Re: Docket No. 366
Development & Management Plan
52 Stadley Rough Road, Danbury, Connecticut

On behalf of Optasite Towers LLC,¹ the Certificate holder, we are writing in response to comments filed by the City of Danbury on the development and management plan ("D&M") materials filed in Docket No. 366.

DRAWING NO.	REVISION:
C-3	A

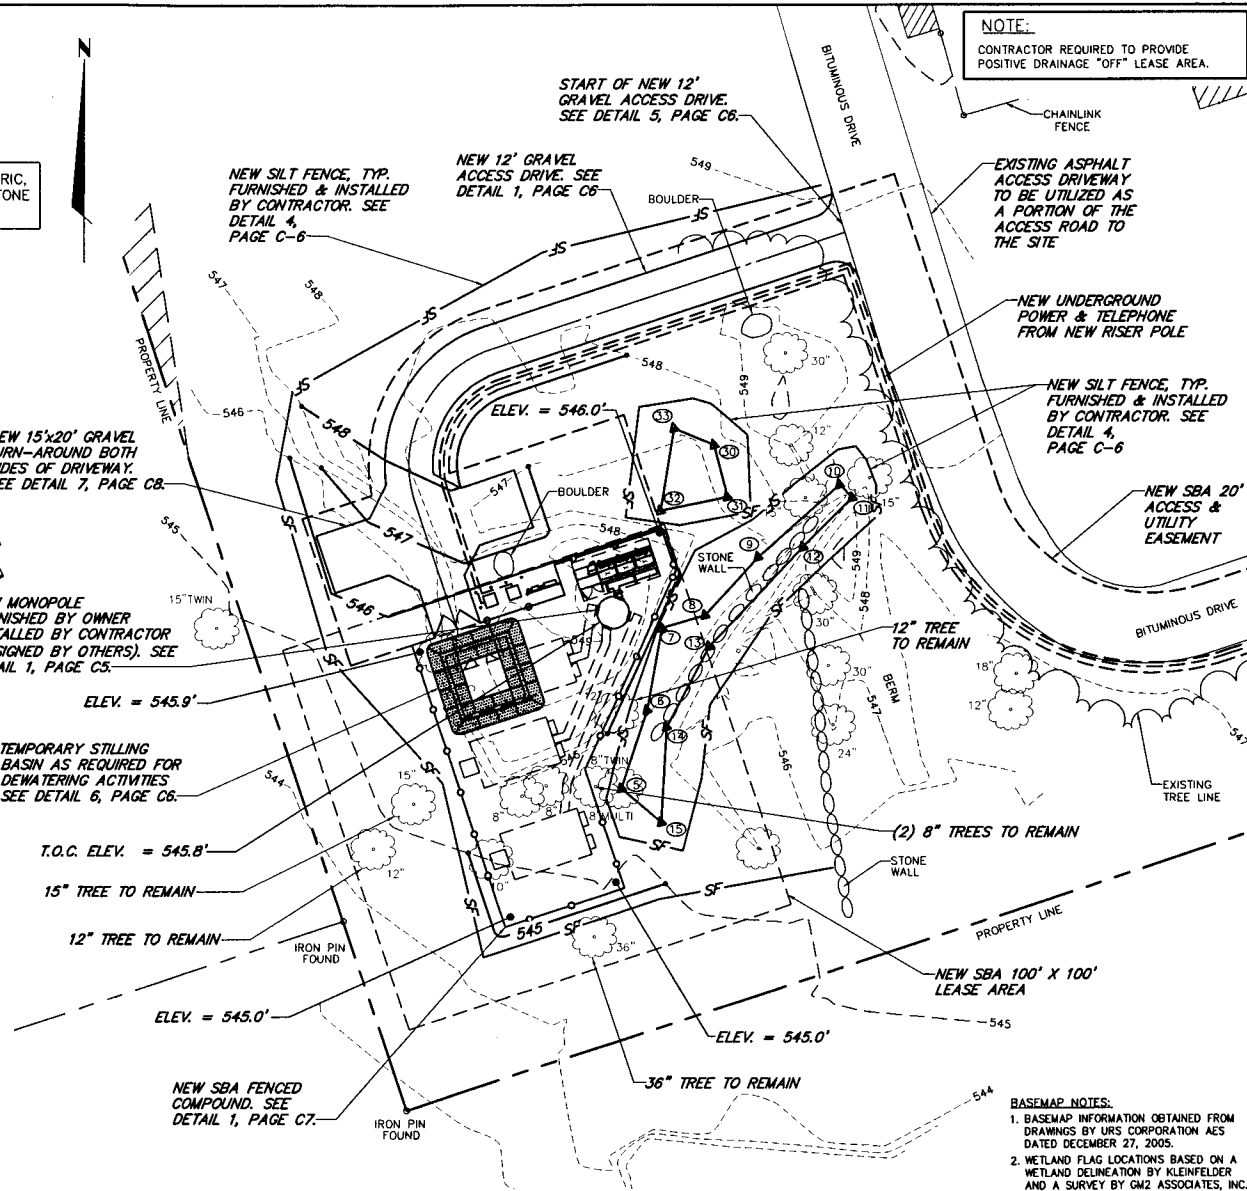
15. The overall site disturbance of 0.4 acres during construction is below the 0.5 acres or more noted on page 3-2 of the 2002 CT Erosion Control Guidelines.

0.04 ACRES OF LAND WILL BE DISTURBED DURING CONSTRUCTION ACTIVITIES, WHICH IS BELOW THE 0.5 ACRE LIMIT NOTED ON PAGE 3-2 OF THE 2002 CT EROSION AND SEDIMENT CONTROL GUIDELINES.

2 COMPOUND FINISH DETAIL

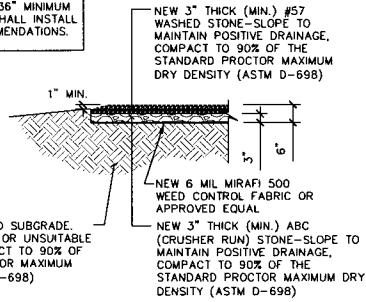
8. Geotextile filter fabric is standard in a tower compound for overall site weed control. See CHA Sheet C-6 for details.
9. Optasite has no objection to tagging those trees to remain in the field and adding a note to the CHA construction drawings to be submitted as part of a building permit application with a copy to be provided to the Council.

DRAWING NO.	REVISION:
C-5	A

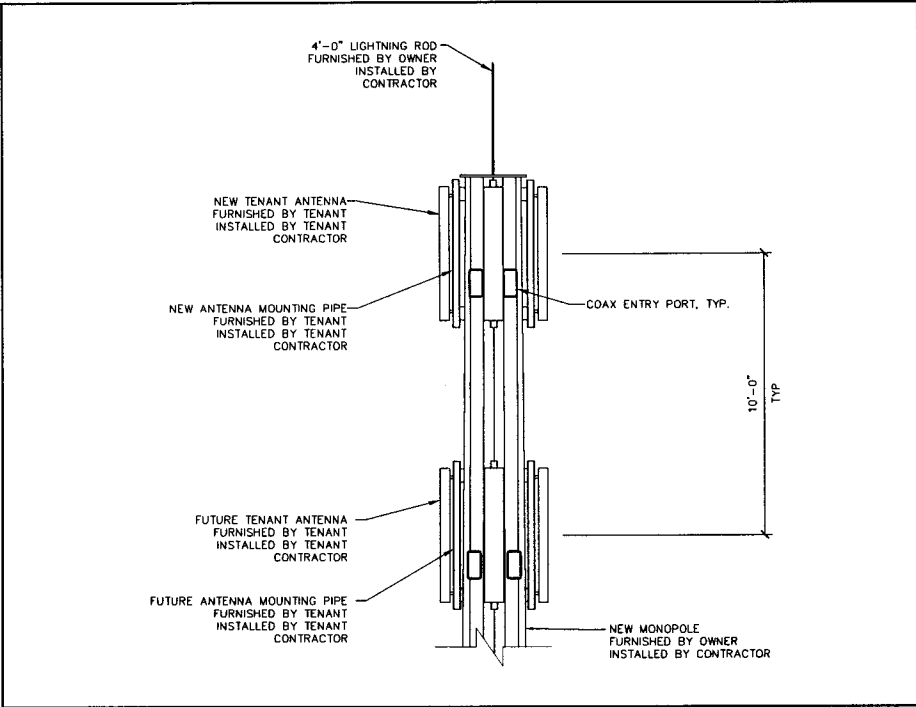
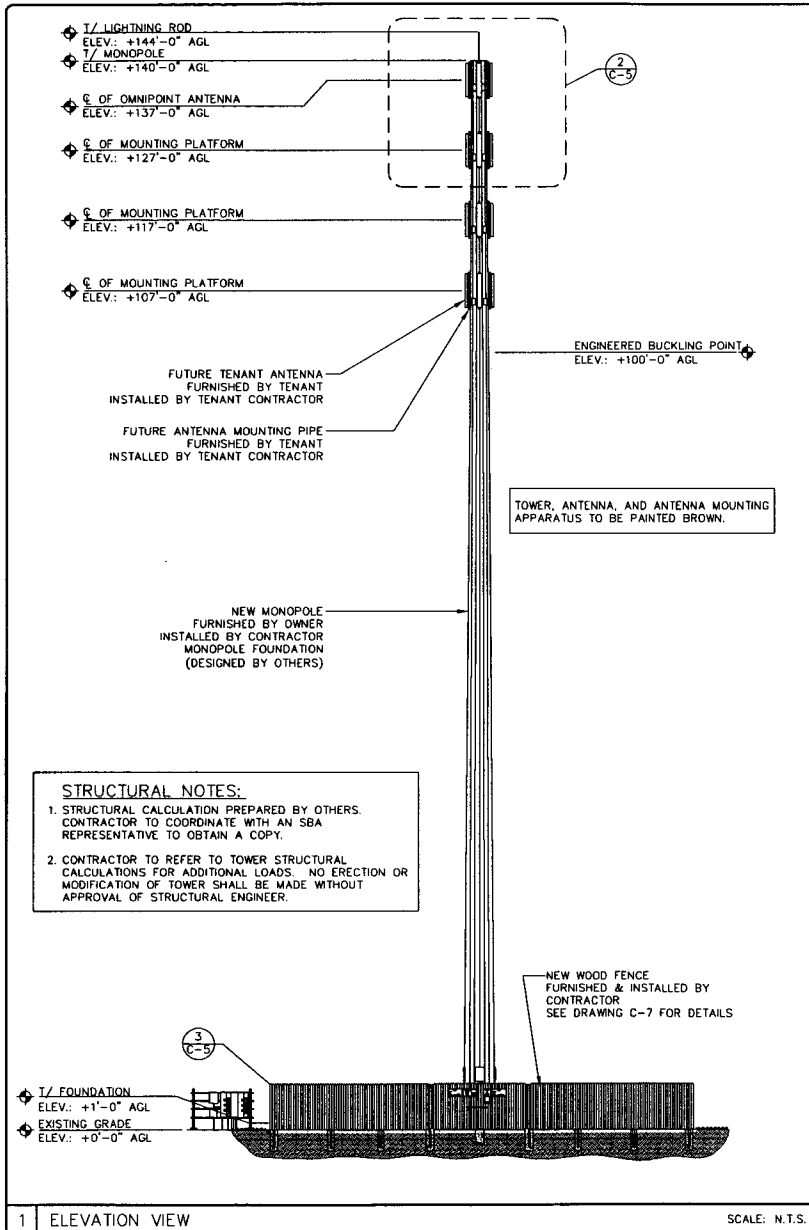
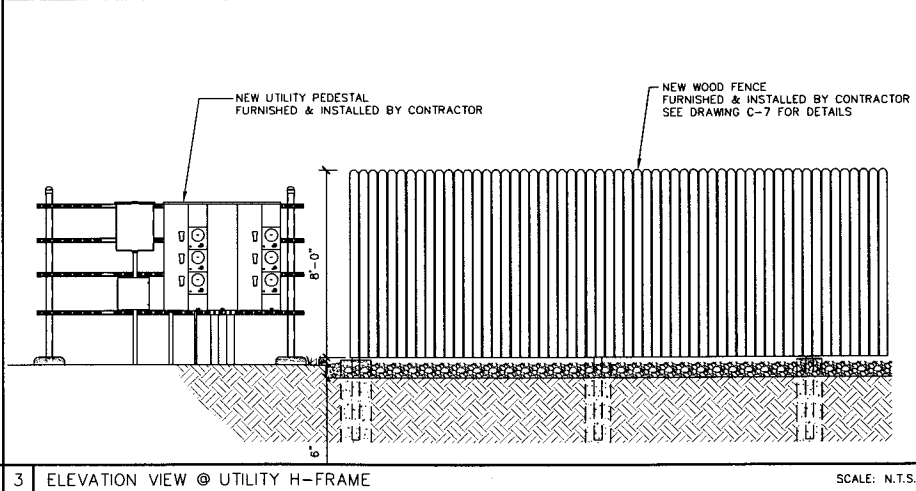
1. The P.E. materials prepared by Rohn note that the lower sections of the monopole, which is a slip joint design, are oversized thereby creating a yield point. The CHA drawings reflect that by reference to an engineered yield point on drawing C-5 at the 100' elevation. CHA construction drawings to be submitted to the City for a building permit will note the slip joint design (as opposed to a flange plate as shown) and a copy of revised sheet C-5 is enclosed for the Siting Council.

2. The Rohn monopole slip joint design and initially designed structural loading for more than the number of antennas shown on CHA drawing C-5 is industry practice and does not affect the structural sufficiency of the tower or antenna locations as shown by CHA on drawing C-5.

5. CHA drawing C-5 and the elevation are revised as noted in point 1.
6. Noted.
7. The CHA drawings show an access drive with a hammerhead turnaround for ease of access to the site which is not a material change in the overall development which involves a reduced site footprint per Council Order #2. The added spur is further away from adjacent properties. The lease area and lease are not implicated by the potential change to the access and incorporation of a hammerhead turnaround. If required by the Siting Council, the single spur turnaround/parking space as shown on the drawings included in the Certificate application can be implemented as a condition of D&M Plan approval.
